**MOBILE SOUTH BUSINESS PARK SUBDIVISION, UNIT
ONE, RESUBDIVISION OF LOTS 2, 3 & 4 OF THE
RESUBDIVISION OF LOTS 4 & 12**

APPLICATION NUMBER 18 DATE September 18, 2008
 APPLICANT Mobile South Business Park Subdivision, Unit One, Resubdivision
of Lots 2, 3, & 4 of the Resubdivision of Lots 4 & 12
 REQUEST Subdivision

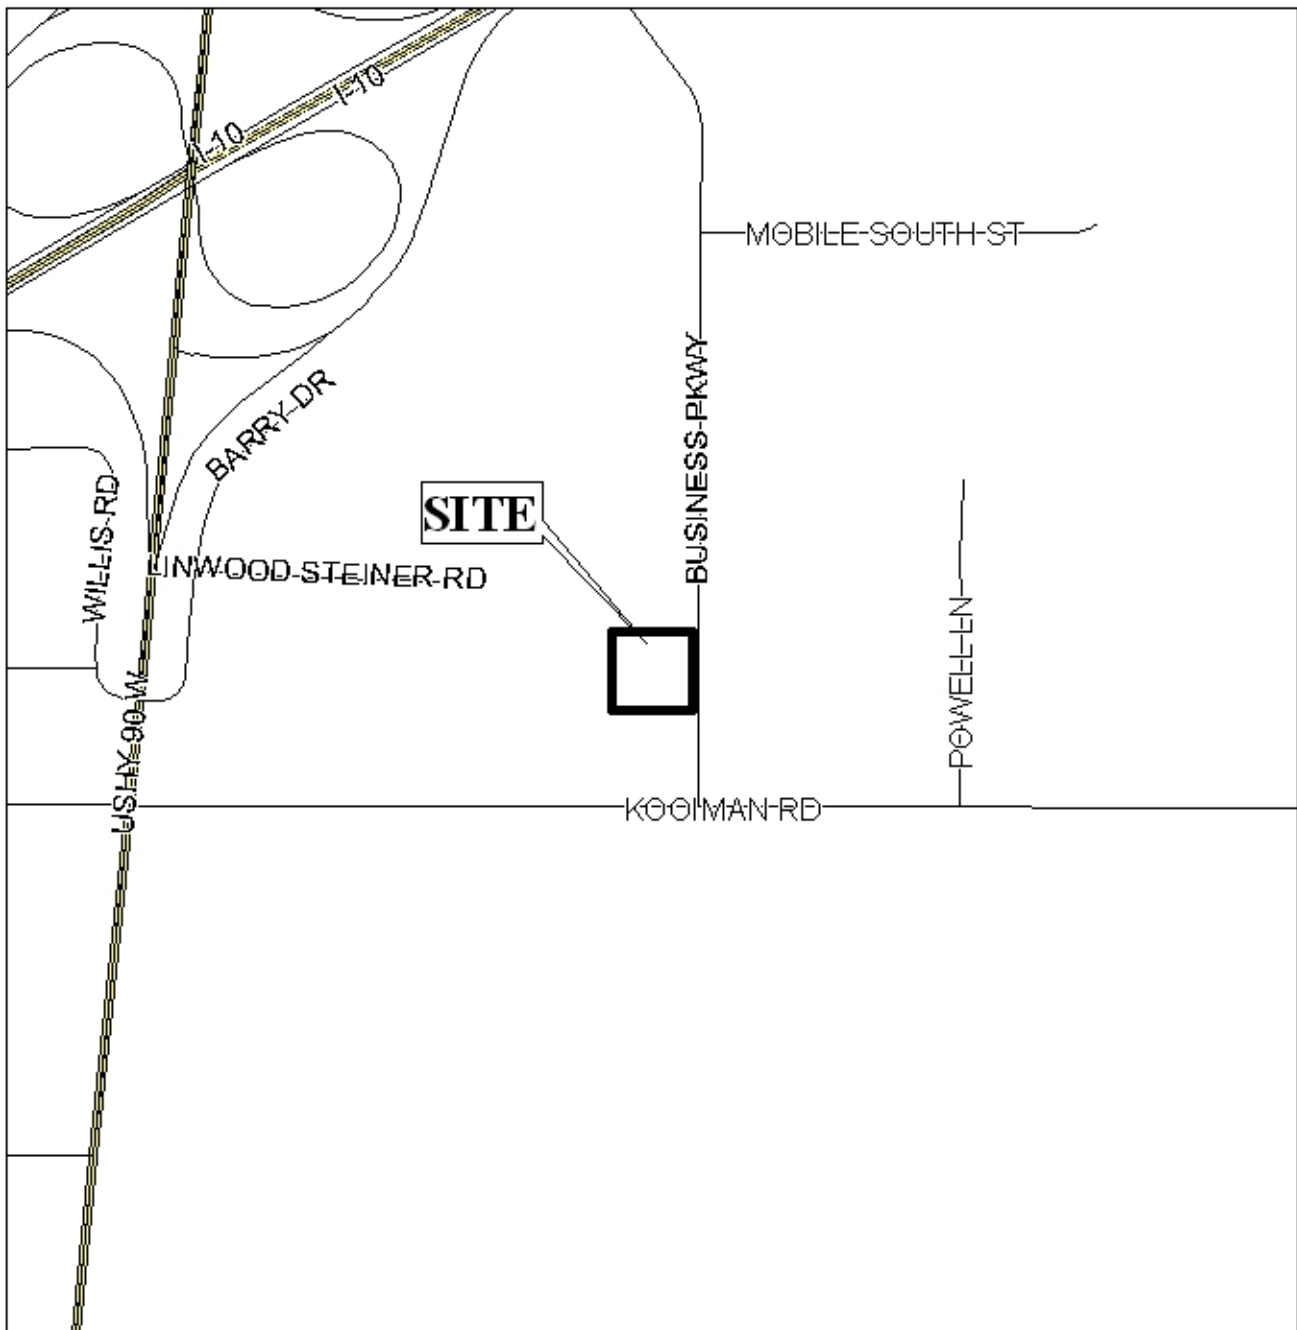
The plat illustrates the proposed 2.0± acre, 2 lot subdivision, which is located on the West side of Business Parkway, 300± North of Kooiman Road. The applicant states the site is served by public water and sewer.

Proposed Lot 1 has approximately 155' of frontage along Business Park Way while proposed Lot 2 has approximately 145' of frontage. As a means of access management, a note should be placed on the final plat, if approved, stating that Lots 1 and 2 are limited to one curb each to Business Park Way with the size, location, and design to be approved by County Engineering.

It should be noted that there are currently two existing structures located on proposed Lot 2. If approved, the structures will meet the required front setbacks.

A note should be placed on the Final Plat stating that any lots which are developed commercially and adjoin residentially developed property must provide a buffer, in compliance with Section V.A.7. of the Subdivision Regulations.

In addition, the lot sizes in square feet, at a minimum, should also be depicted on the final plat, or a table provided furnishing the same information, if approved.

- 1) Placement of a note stating that Lots 1 and 2 are limited to one curb cut each onto Business Park Way, with the size, location and design of each curb to be approved by County Engineering;

- 2) Placement of a note on the final plat stating that any lots which are developed commercially and adjoining residentially developed property will provide a buffer, in compliance with Section V.A.7 of the Subdivision Regulations;
